June 12, 2025
Updated June 17, 2025
ES-9607.02

**Subject: Response to Review Comments
 Cheshire Property
 7615 East Mercer Way
 Mercer Island, Washington**

As requested, Earth Solutions NW, LLC (ESNW) has prepared this response to review comments letter for the subject project. This response letter addresses city of a city of Mercer Island review comments in the referenced review letter. This update includes a review of the latest submittal plans.

Drawn CAM
Checked SSR
Date 06/11/2025
Proj. No. 9607.02
Plate 2

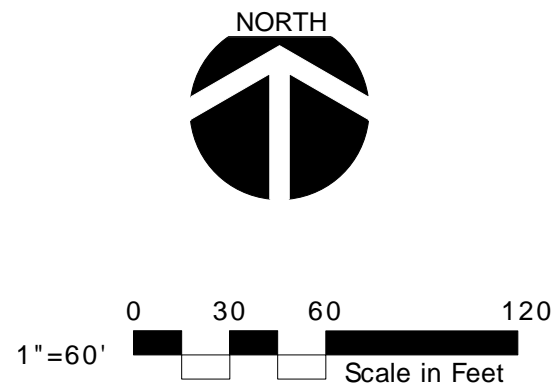
2. *Please provide a scaled site plan with elevation contours showing the boring locations.*

Attached.

ES-9607.01
Cheshire SFR
Static Condition

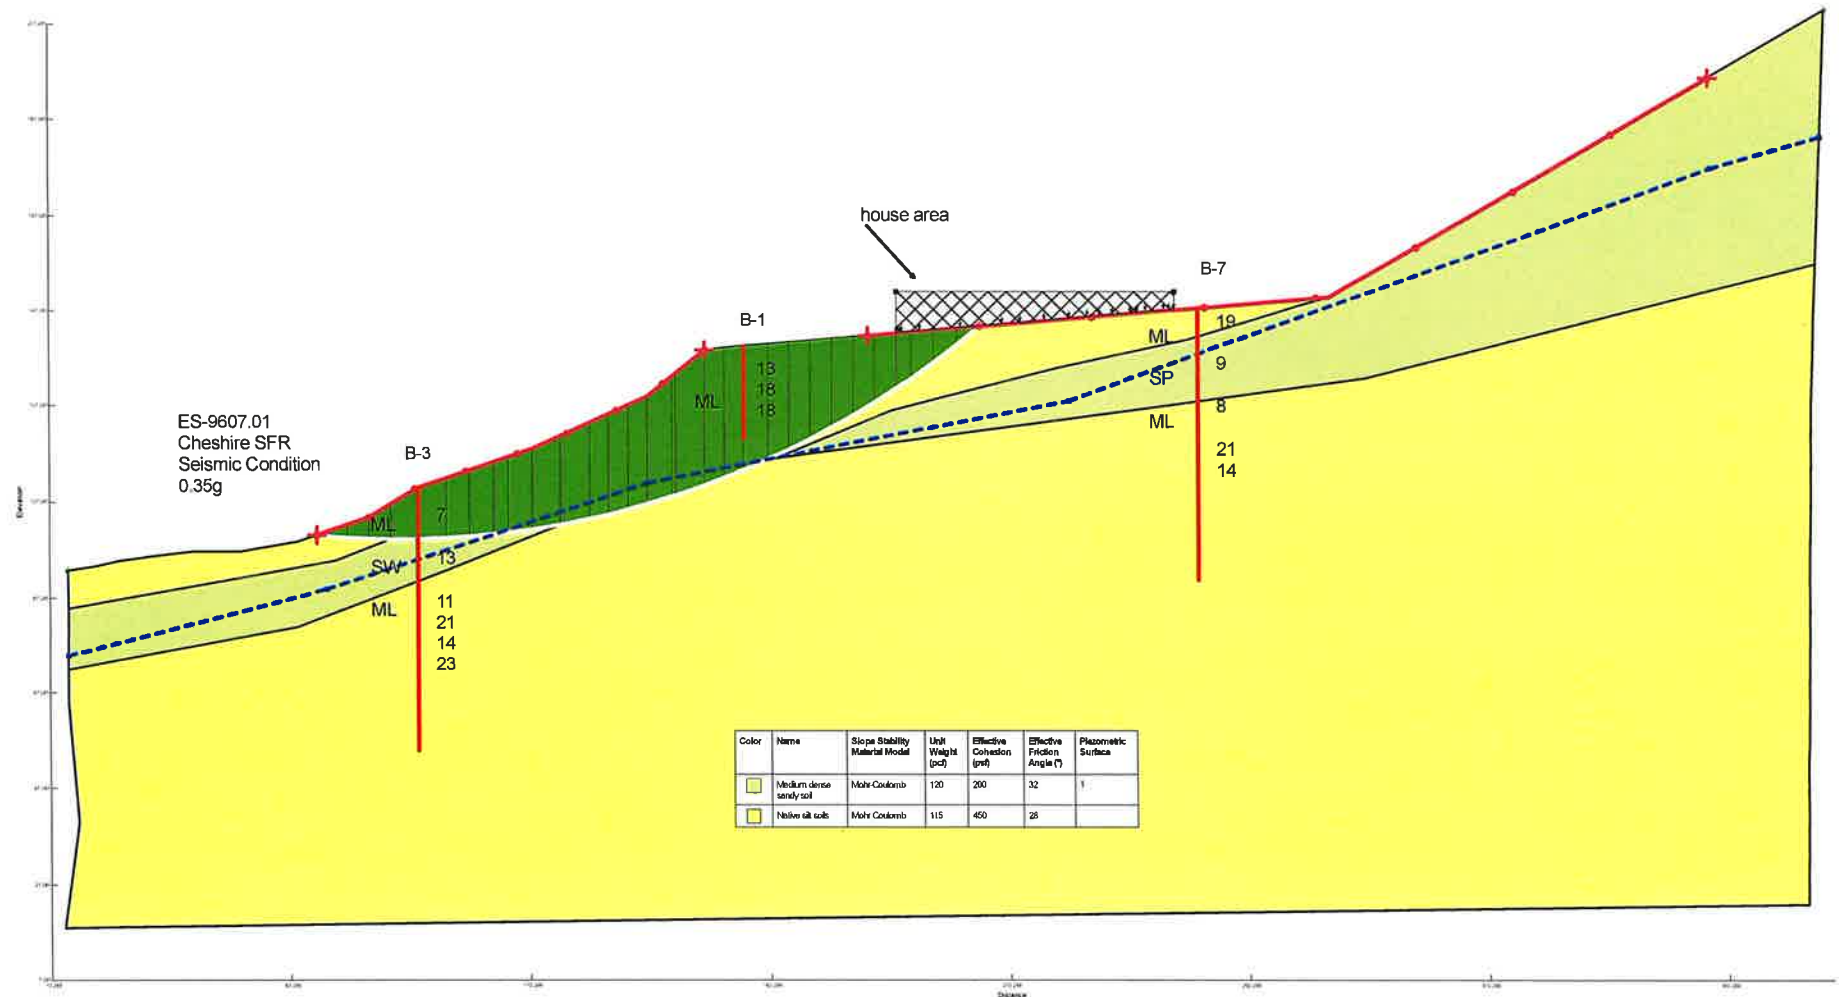
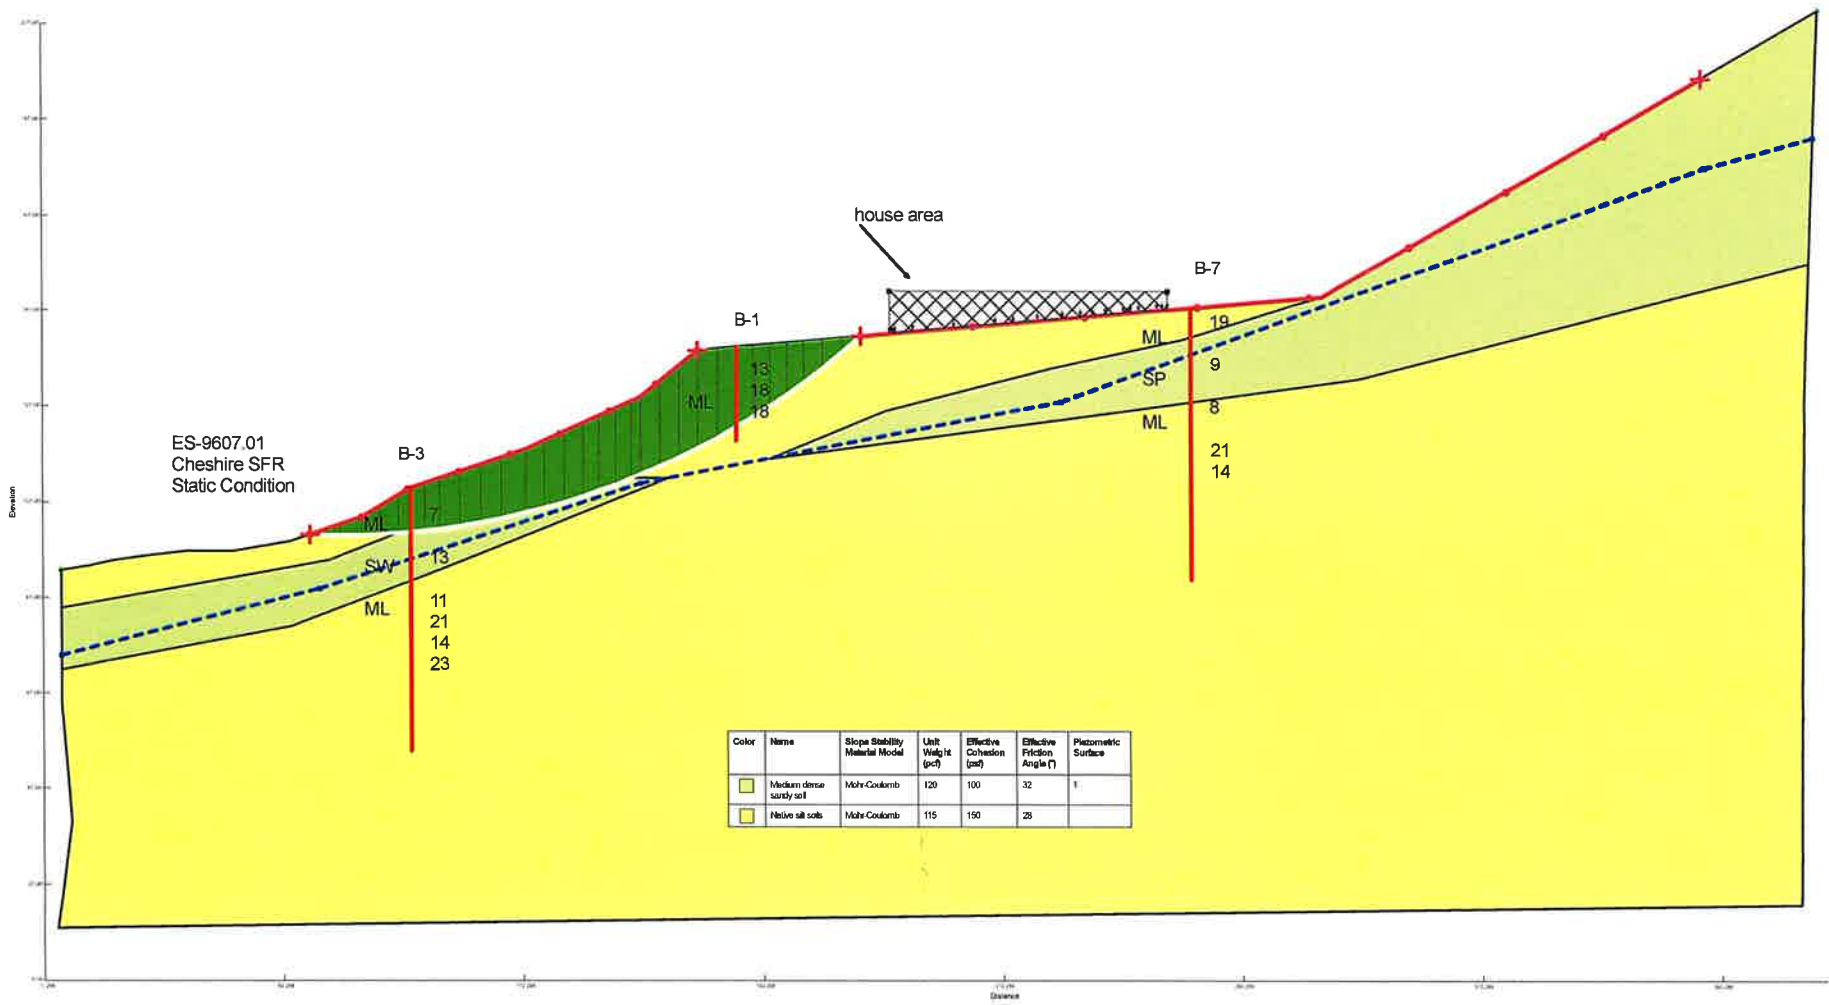
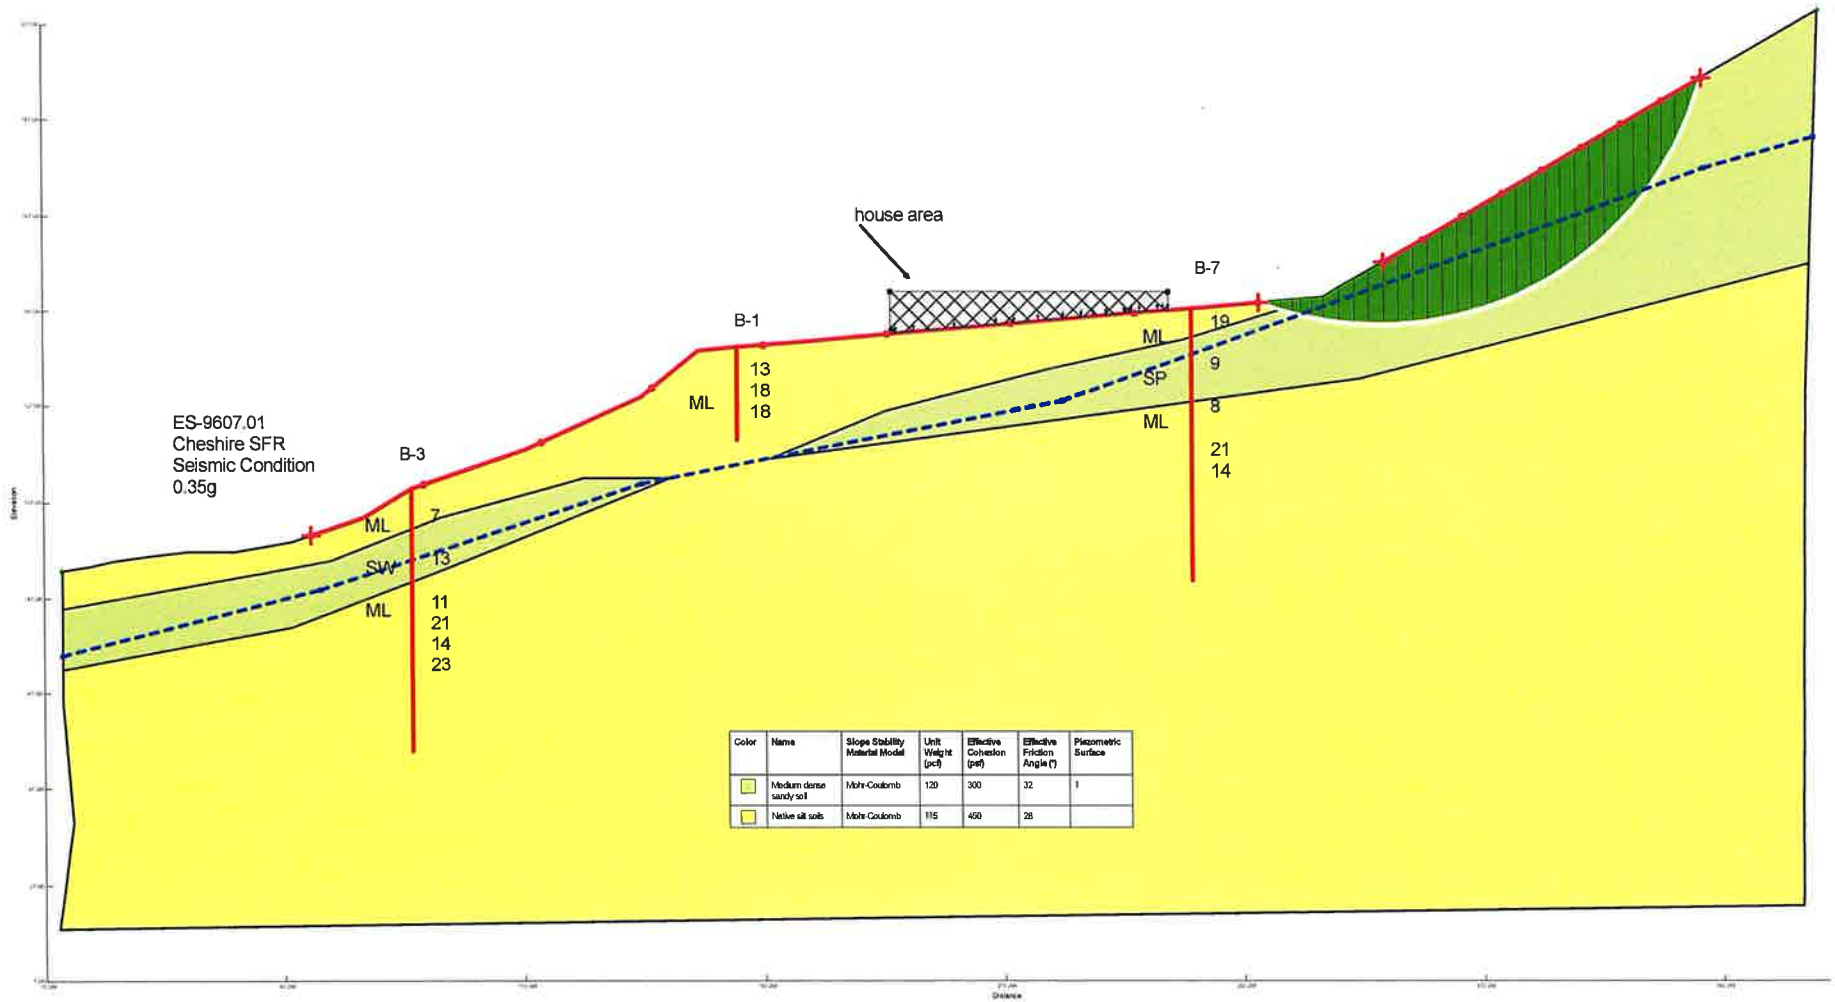
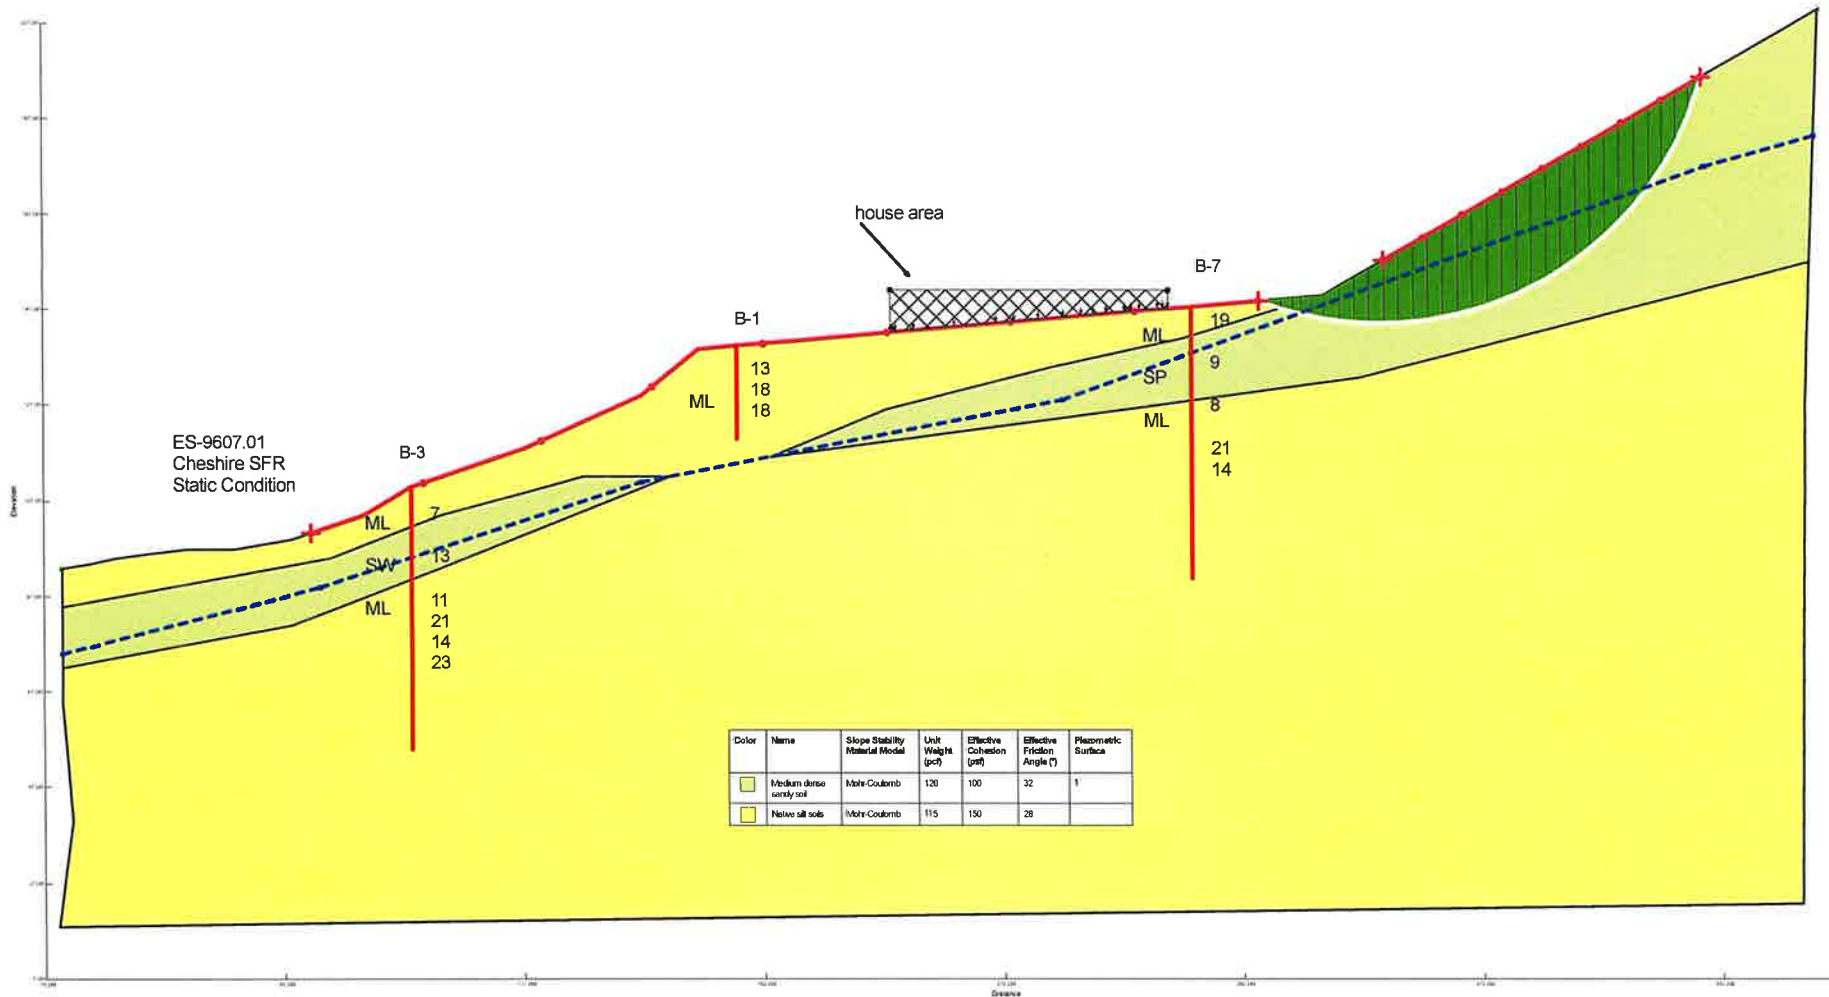
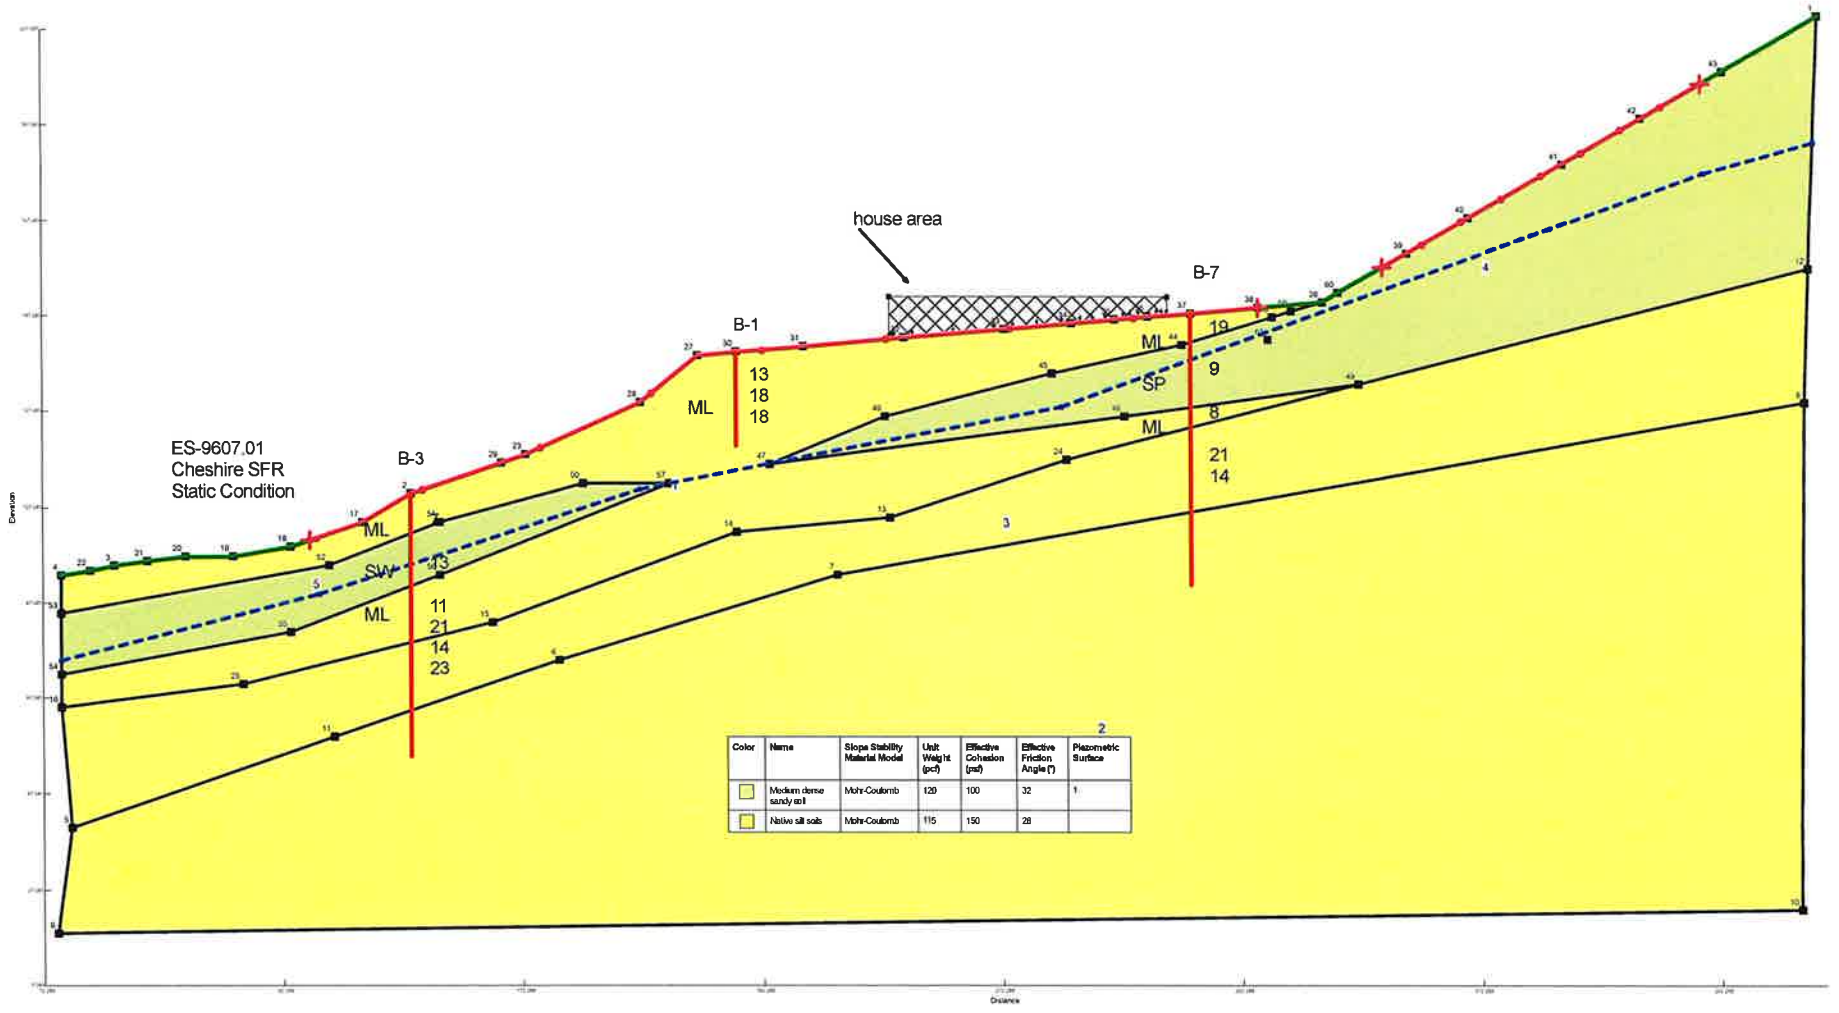
4. *Please provide a slope stability assessment of the entire site (including the slope west of the residence) under static and seismic loading conditions.*

- 6. Please show on the slope stability cross-sections the locations and subsurface information (SPT, soil type and groundwater condition) of the borings used to generate the stratigraphy shown on the sections. Please provide discussion on the stratigraphic changes from one section to another and how the groundwater level was determined across the sections.*

7. *Please review the soil strength values assigned under seismic loading conditions and provide supporting information for their use. An increase in cohesion while maintaining the same effective friction angle would result in a higher factor of safety against slope instability under seismic loading which would not be expected. Please revise soil strengths and slope stability analyses.*

Included as an attachment to this response letter.

Requested information included in updated SlopeW output attached. We updated the soil layers to include additional saturated sandy layers. This analysis does not account for the gradation between layers and related 'fabric' of the soil underlying this site. With respect to groundwater, while the soil logs report groundwater, it is not within a consistent layer or zone on this site, rather, it's reported within the sandier deposits that vary across the slope. The updated SlopeW analysis applies a groundwater condition under the entire slope. Comparing the updated SlopeW analysis to the version previously submitted, it appears that minimum factor of safety (FOS) values are relatively consistent and suggest that, while there may be isolated areas of instability, such as within the slope to the west, global site stability does not pose an increased threat to the property. We applied a relatively thick layer of silty sand soil to the western slope, as a conservative approach given the limited amount of subsurface data. We expect much of the core of this slope to be comprised of dense/hard silt deposits. The slope stability modeling focused on the soil and groundwater conditions under the proposed building. It is acknowledged that soil, groundwater and terrain vary across this site, including the existing DADU. On this basis, in our opinion, the overall stability of the site is acceptable from a geotechnical standpoint. This analysis further supports the use of a structural fill mat and woven geotextile under new foundations, that will provide a uniform support and help reduce the potential for differential settlement that may cause the building to collapse. As is standard for any site located on a slope, should a maximum credible earthquake event occur and trigger movement, the goal is to prevent structural collapse, while acknowledging that severe damage to the overall site may occur. This is supported by the age of the existing building that was subjected to the Nisqually earthquake in 2001 and shows little to no signs of obvious foundation settlement or displacement. The recommended foundation support approach will provide a significantly more robust and resilient support system for the new building.

The local standard for modeling seismic soil conditions includes an apparent cohesion value to account for negative pore pressure and other related soil characteristics in a dynamic loading condition. This is consistent with local standards and based on published recommendations for values, including FHWA.
